# Access Compliance Report

## Public Rights-of-Way

### (Pedestrian Signals)

Intersection ID: N/A	Main Street:	Cross Street: N/A	Location: N/A
ADA ID: 887BDF177FE1	Signal Type: One Push Button-Non APS	Overall Compliance: No	Severity Score: BTN 1: N/A BTN 2: N/A No BTN: N/A
Codes/Mitigation Info/Possible Solution		Field Measurements/Component Compliance

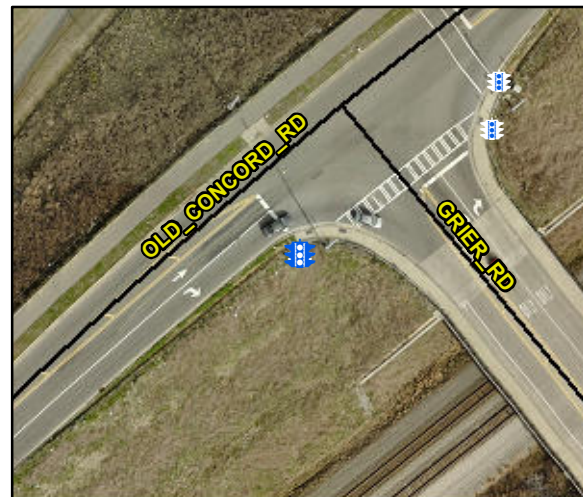
Surveyor Notes: TEXT HT 7/16, GUARD RAIL BETWEEN SIGNAL AND SIDEWALK

PROW/ADA: R410.6, TMUTCD 4e.08, R404.2, R404.3, R406.2, R404.7.3

Possible Solutions: Replace Signal Push Button With APS Button on New Post. Remove & Replace Sign.
